BB7  
3671 - Hillingdon  
Proposed Disabled Refuge Locations  
BB-DRC-3671-02  
10<sup>th</sup> January 2020  
Review by: Thomas Gibbins  
Authorised by: Dane Owen

**5 Building 7 - Roof Plan**  
1 : 200

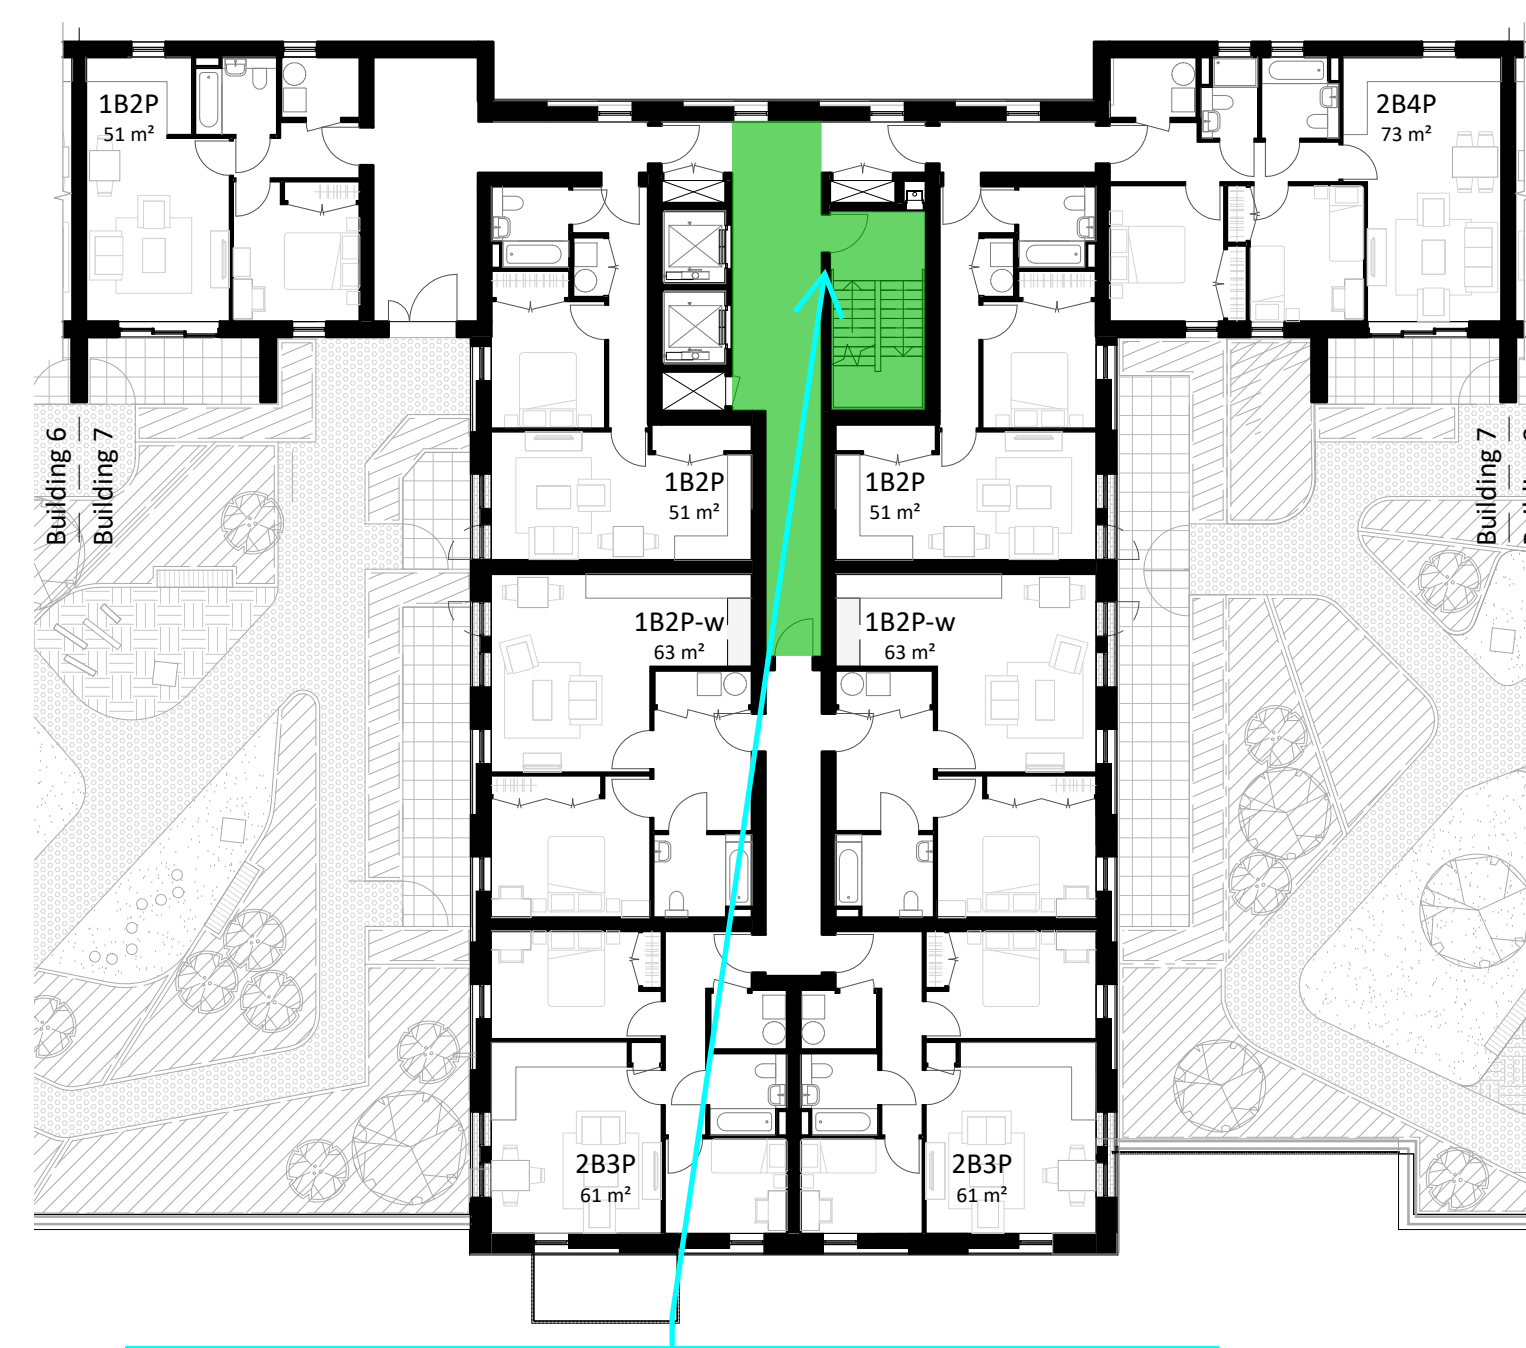
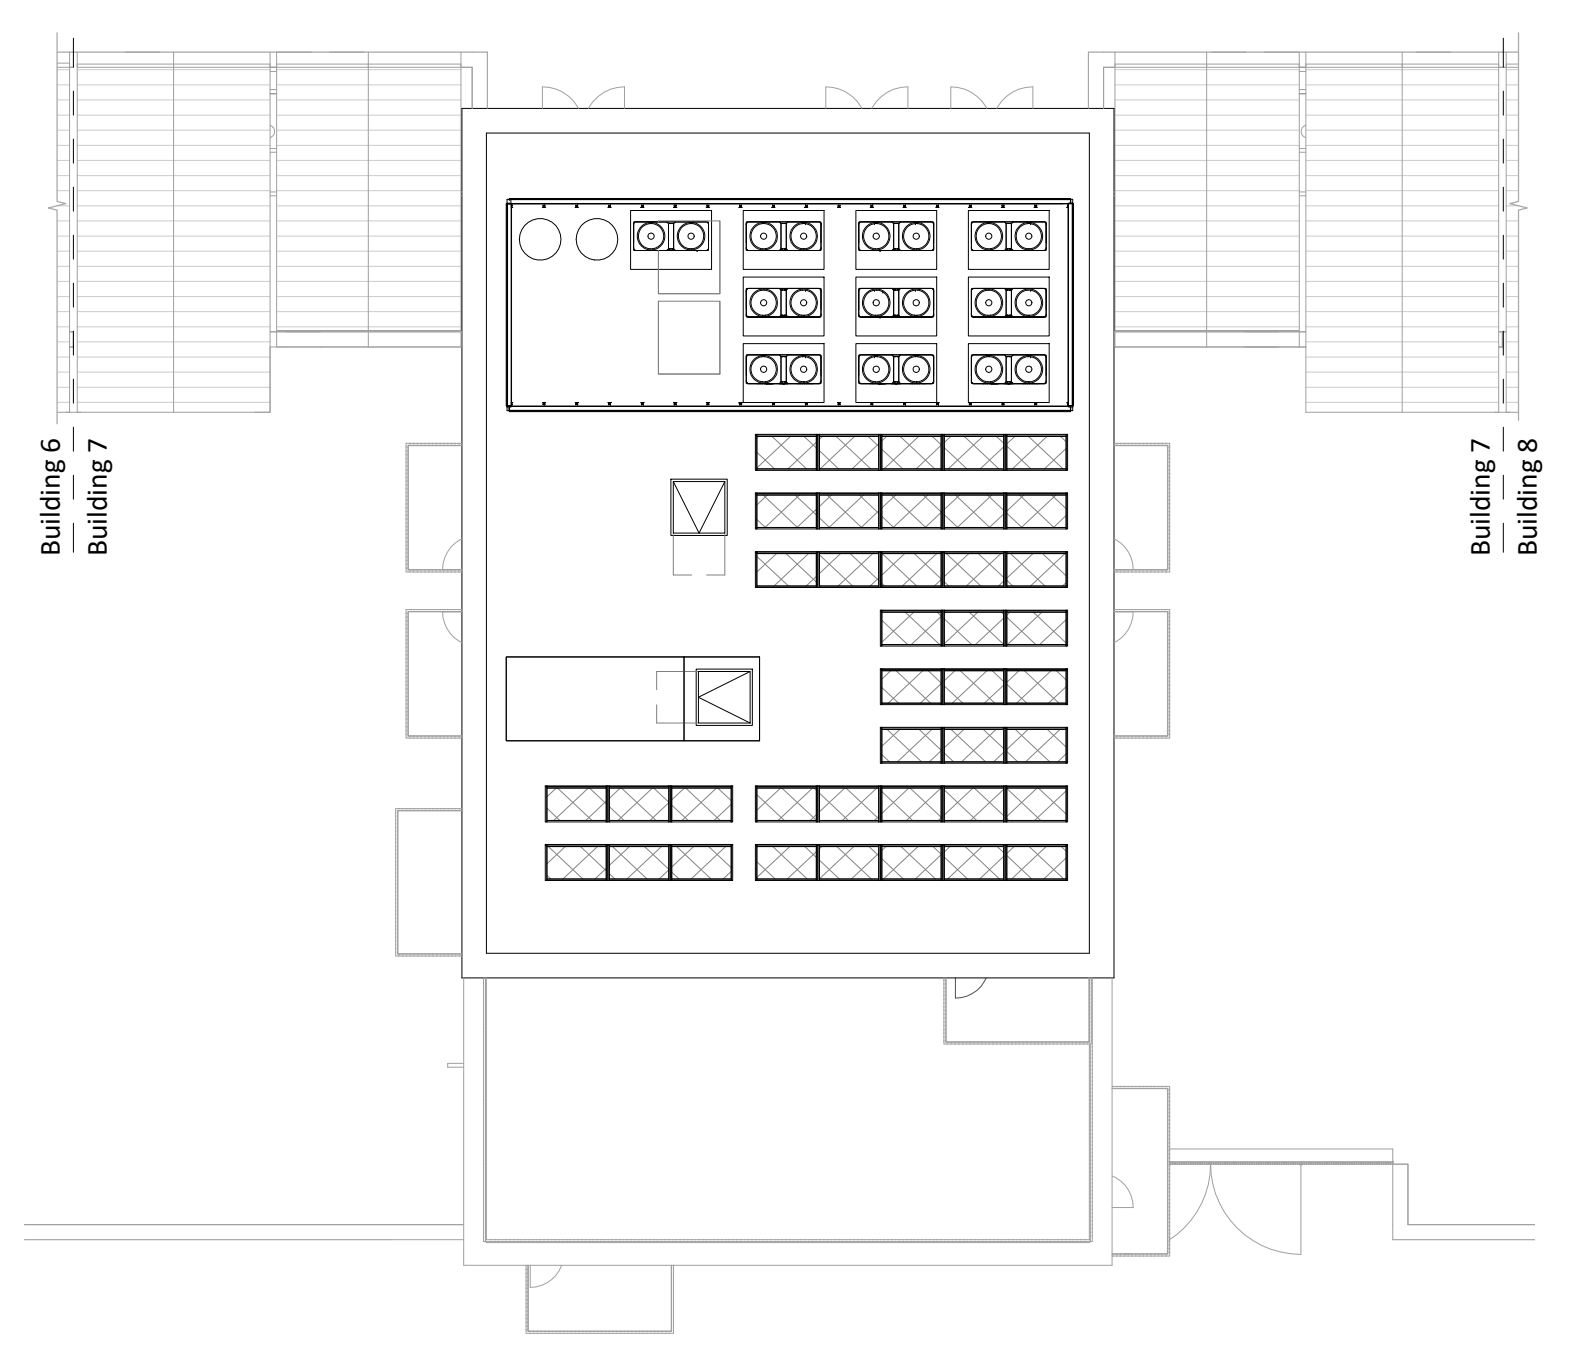
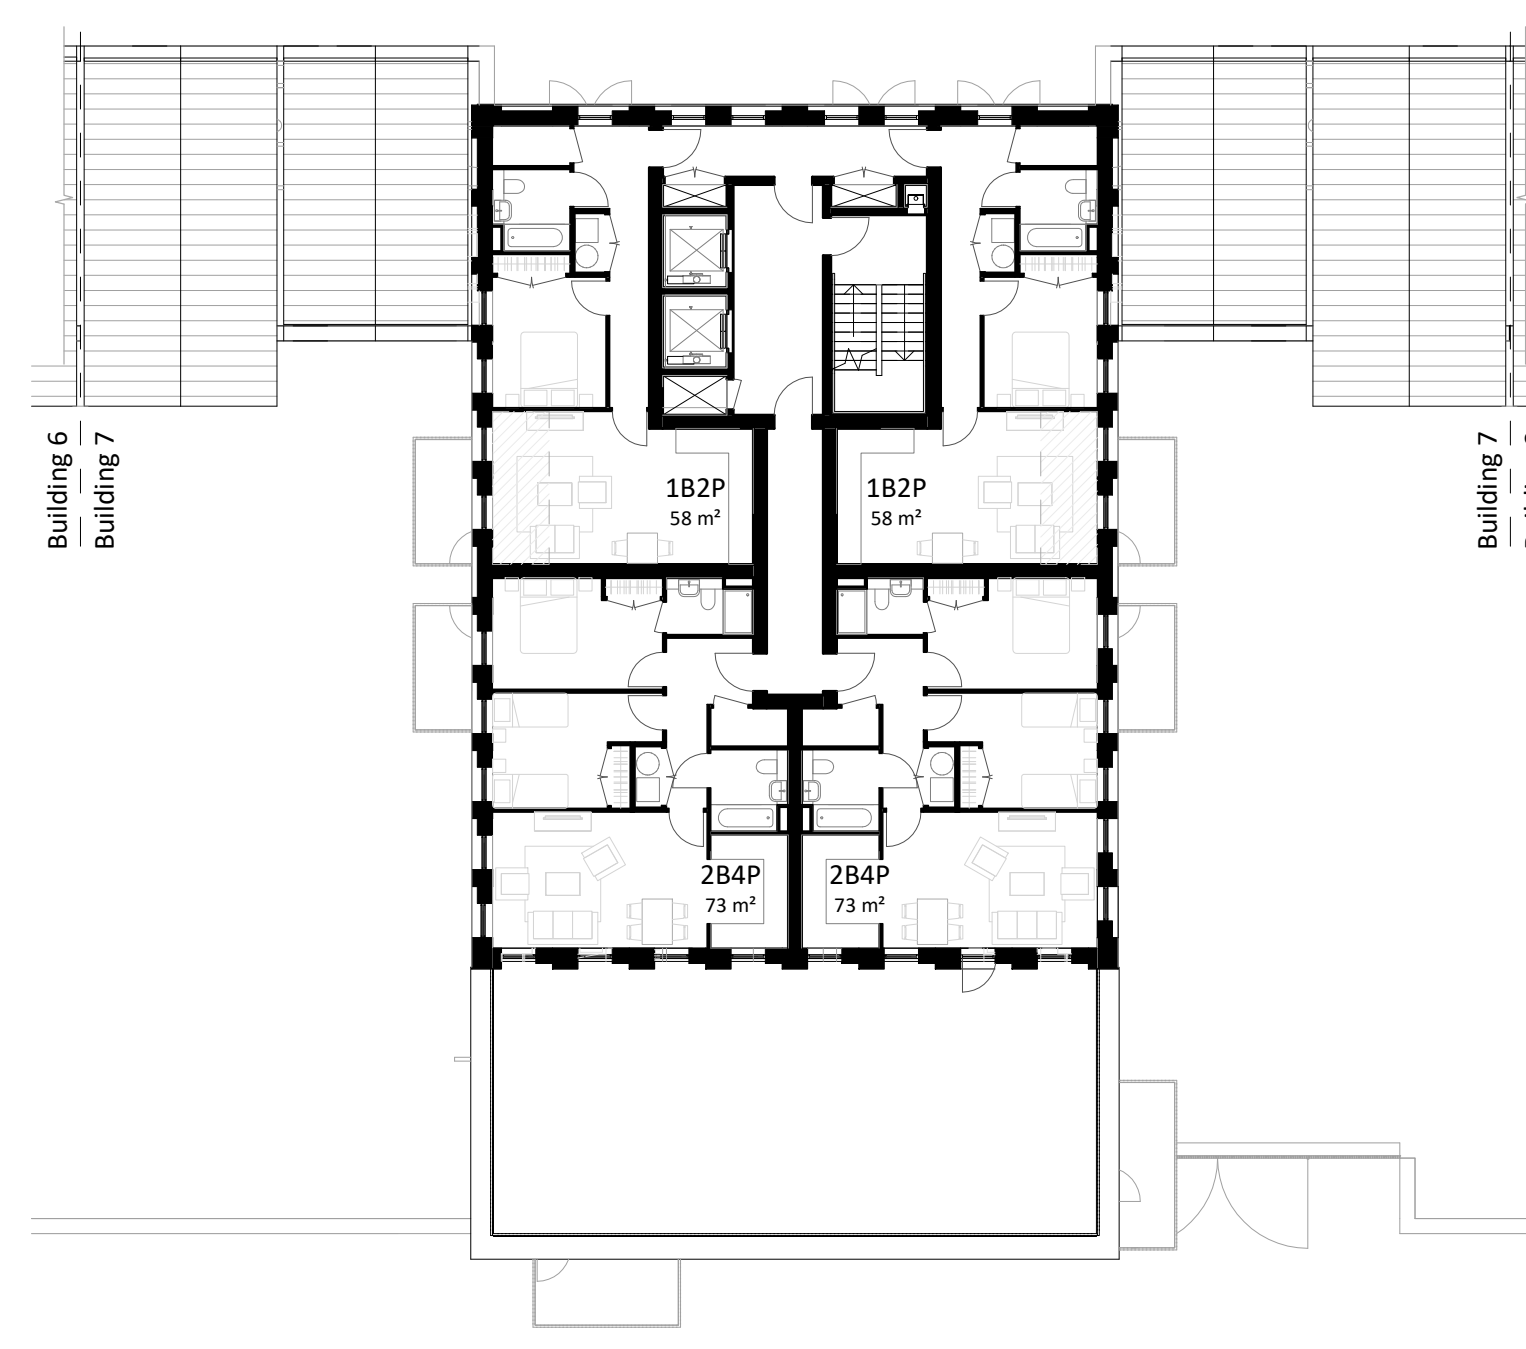
To be noted, if the roof terrace is to be used by the residents (i.e. not maintenance only), there is a risk that disabled guest may be present in a fire scenario. As such, until agreed to be omitted at the detailed design stage, it is recommended that on this level a disabled refuge is allowed for in the staircase/lobby. Disabled refuges are to be a minimum 1400mm by 900mm and are to not impede the escape route.

**4 Building 10 - Roof Plan**  
1 : 200

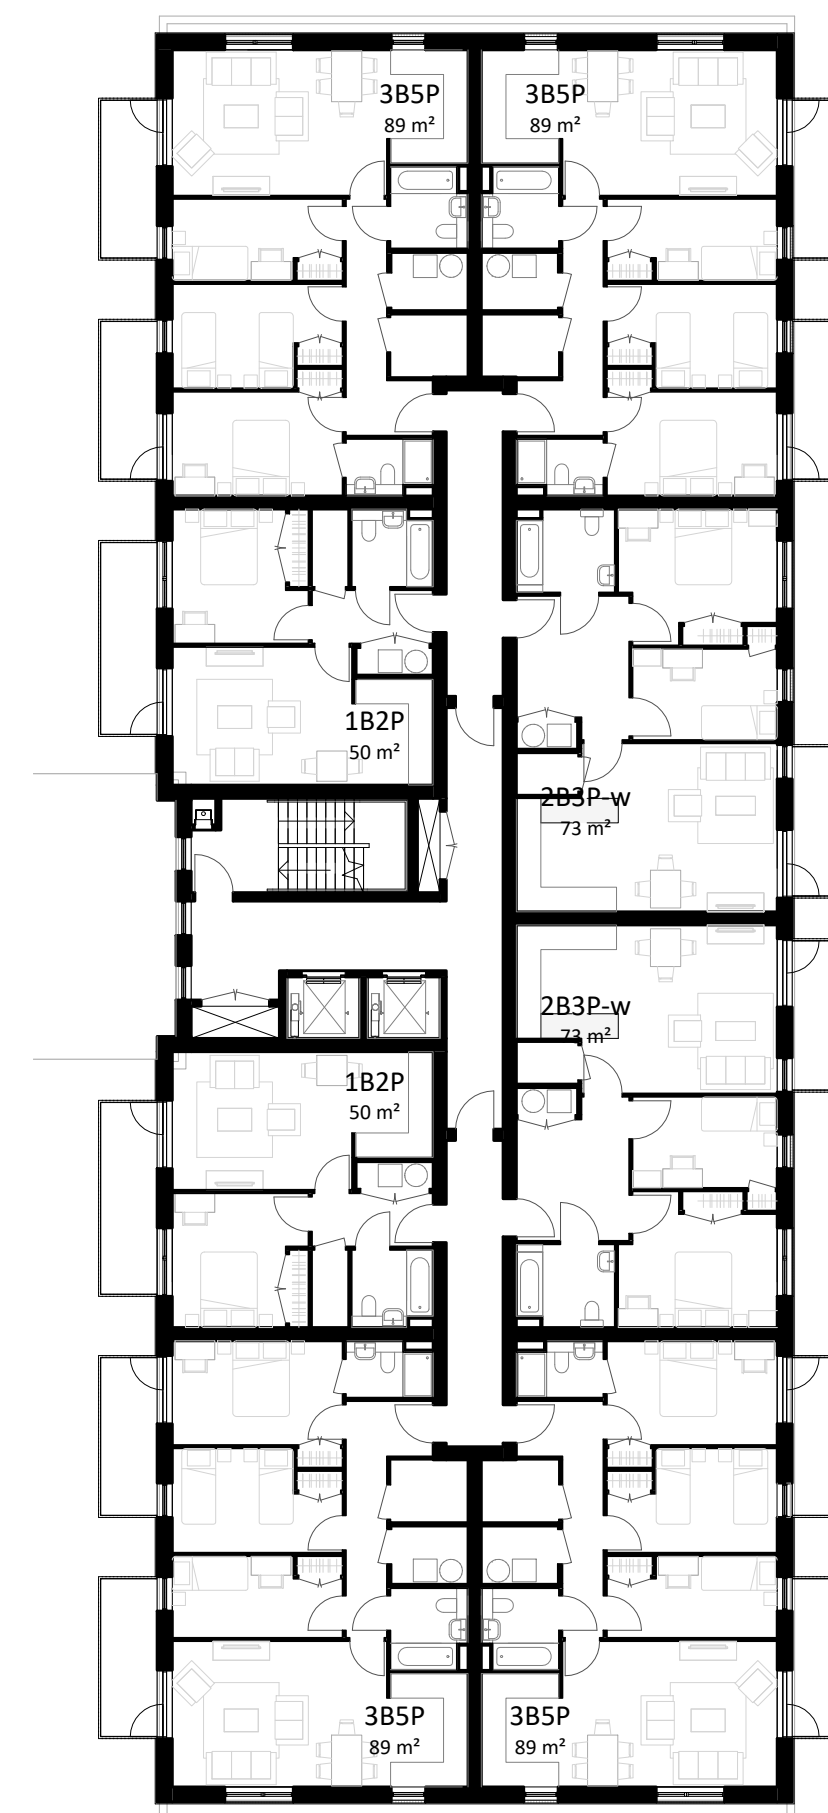
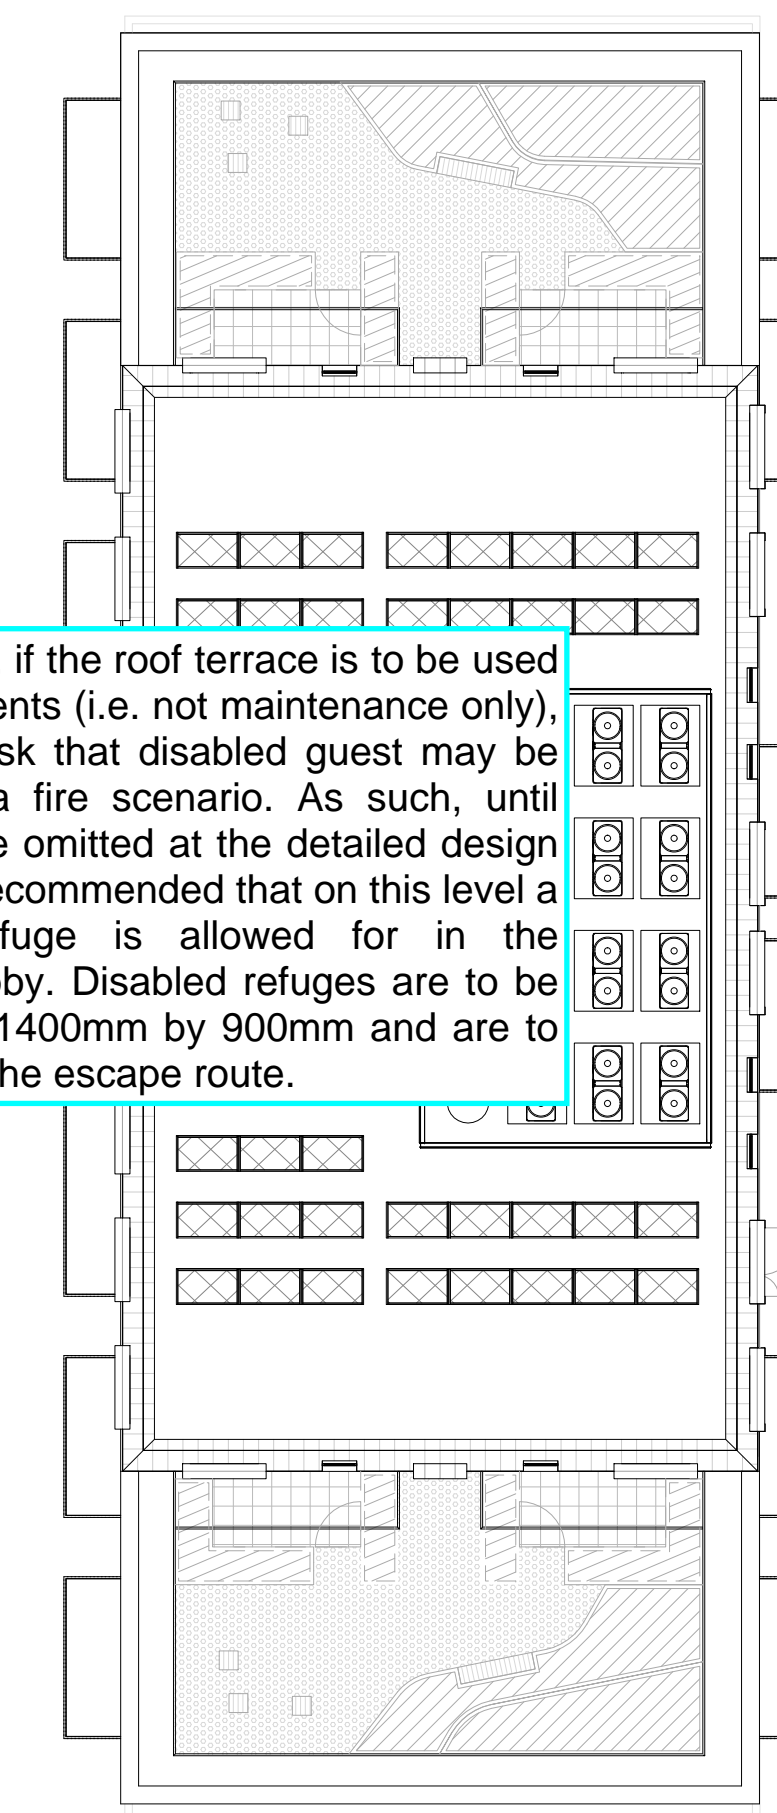
To be noted, if the roof terrace is to be used by the residents (i.e. not maintenance only), there is a risk that disabled guest may be present in a fire scenario. As such, until agreed to be omitted at the detailed design stage, it is recommended that on this level a disabled refuge is allowed for in the staircase/lobby. Disabled refuges are to be a minimum 1400mm by 900mm and are to not impede the escape route.
